IDAP REPORT

| Property: | 8 Howard Street, Strathfield Lot: 7 DP: 12405 DA2021.47 |
| Proposal: | Demolition of existing structures and construction of a two-storey dwelling house with basement level. |

Figure 17. Extract of the proposed western elevation.

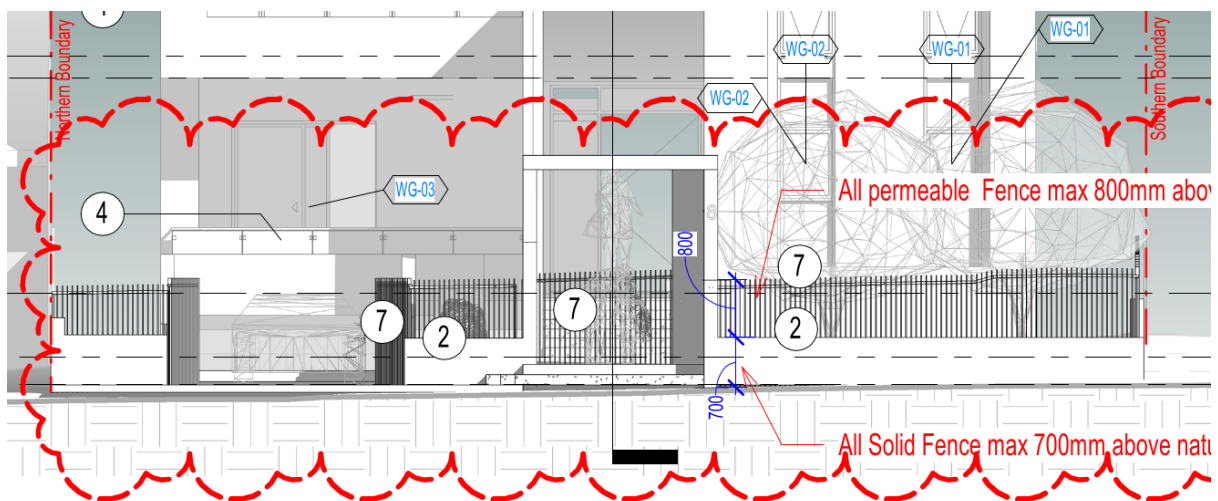
The western elevation demonstrates measurements for the front fencing of 1.5m in height and the solid components, a height of 0.7m. However, the elevation drawing shows inconsistency in height, as per the image below.

To ensure that the front fence will have a height that is consistent with the SCDCP 2005, a condition of consent will be imposed accordingly.

Figure 18. Extract of the proposed ground floor plan.

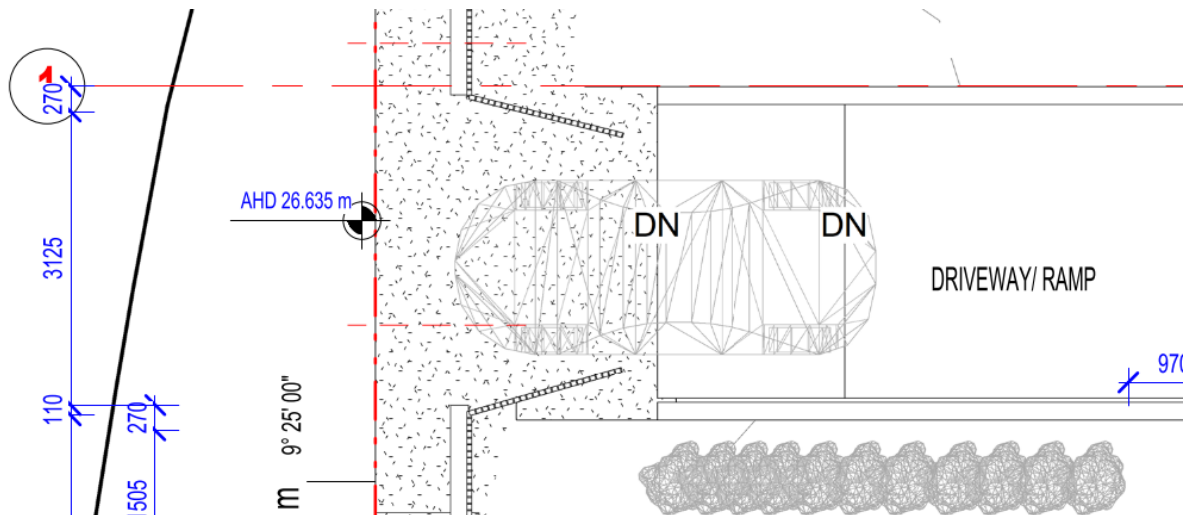
The SCDCP 2005 requires a driveway width at property boundary to be no more than 3m. The proposed ground floor plan, as shown in Figure 18 below, while indicates a measurement of 3.13m driveway width is proposed, that is not the case. The driveway width, when measured using the scale provided, is 3.5m, which is not supportable.

To ensure that the driveway, at property boundary, will be consistent with the requirements of the SCDCP 2005, a relevant condition of consent will be imposed.

Figure 20. Extract of the proposed basement floor plan.

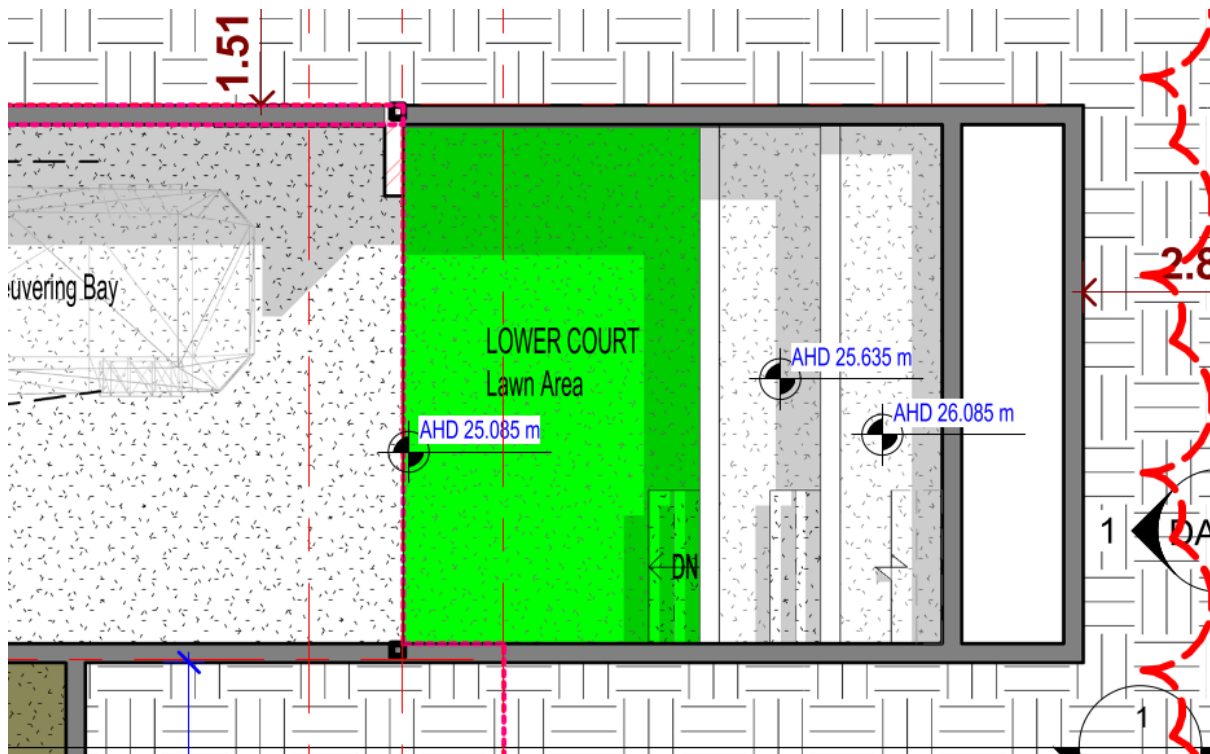
The proposed development includes a feature at the rear of the property that involves staggered excavation, resulting to a stepped landscaped area that leads into the basement.

Taking into consideration the topographical features of the site, this design will result to a retaining wall of about 2.17m, which is not compliant with the requirements of the SCDCP 2005. The SCDCP 2005 Part A requires that a retaining wall must have a height of 1.2m.

Notwithstanding the non-compliance to the numerical requirement for retaining walls, the proposed stepped landscaping does not satisfy the objectives of Clause 9.1 of the SCDCP 2005, in particular – “A. to maintain existing ground levels and minimise cut and fill to reduce site disturbance.”. Further, an issue with drainage was raised by Council’s Development Engineer as the proposed terraced landscaping may not allow runoff to drain into the basement pump pit.

Given the reasons above, the proposed terraced landscaping is not supported. As such, a condition of consent will be imposed requiring the deletion of this section and closing off the eastern side of the basement.

| Terraced/stepped landscaped courtyard | <p>To be deleted.</p> <p>Basement is to be enclosed by constructing a wall from point H1/1H to point H2/2H in the Basement Plan.</p> |

1. Overshadowing

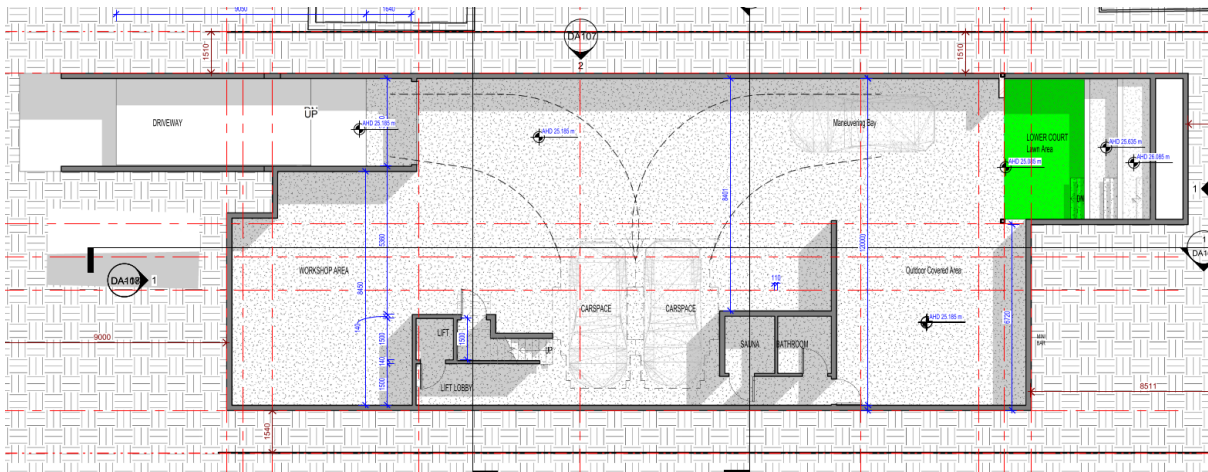
A concern was raised that information on the existing shadow diagrams should be provided to better assess the difference of potential solar access impacts. It is noted that the existing structures on the site comprise a single-storey dwelling house and detached garage. As these structures are single-storey, any overshadowing impacts in relation to these elements are considered minimal.

It is noted that the west-east orientation of the site ensures that overshadowing impacts on the south-adjointing neighbour will be inevitable. Further to the above, the controls under Part A of the SCDP 2005 requires a minimum of three hours of solar access during mid-winter to be facilitated for windows of habitable rooms and at least 50% of the POS of neighbouring properties. The proposal demonstrates compliance with this requirement, as shown in Figure 21 below. Therefore, the potential overshadowing impacts associated with the proposal are considered reasonable and acceptable.
